PROPOSAL: Two Multiple Dwellings (One New & One Existing)

LOCATION: 12 La Perouse Street, Warrane

12 La Perouse Street, Warrane TAS 7018

Revision D - window/elevation dimensions, privacy clarification and landowner consent package

ORIGINAL DA SITE PLAN - RFI REV D OVERLAY

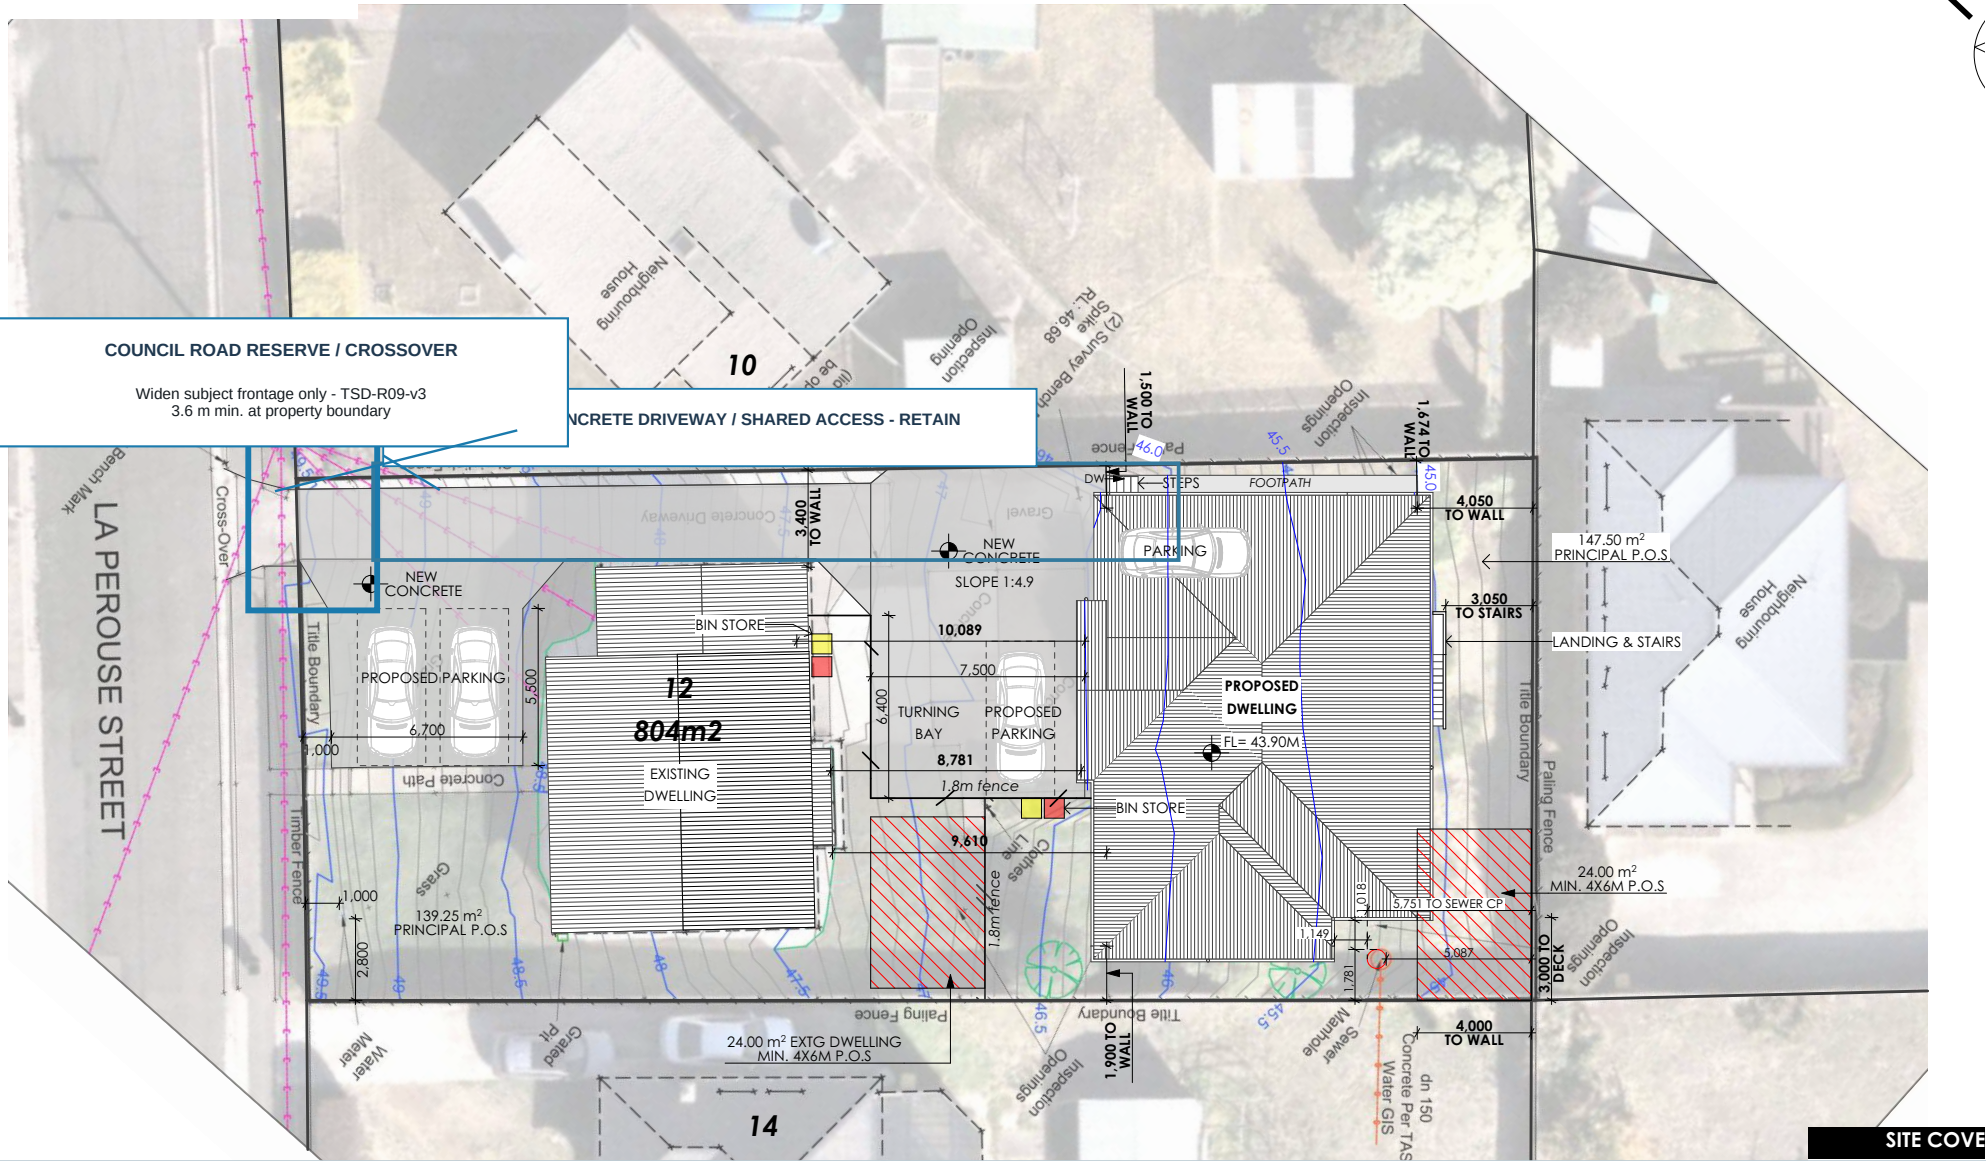
PLAN NOTES: EXISTING crossover/driveway retained except widening at the subject frontage, PROPOSED NEW CONCRETE is shown on the architectural plan. Existing front-dwelling parking remains at the street/front. Rear-dwelling vehicles use the shared driveway to the rear turning bay / garage. No road-reserve or crossover work is proposed on adjoining properties.

- 1 LANDOWNER CONSENT**
Completed Council Landowner Consent Form dated 14/09/2026 accompanies this plan.
- 2 ROAD RESERVE**
The crossover widening occupies only the La Perouse Street road reserve directly in front of No. 12.

- 9 FINAL LEVELS**
Kerb profile, footpath, grades, drainage interfaces, services and tie-in levels are to be field verified to Council requirements.
- 10 READ WITH**
Read with architectural site plan, B85 manoeuvrability drawing and CT Engineering stormwater/service drawings.
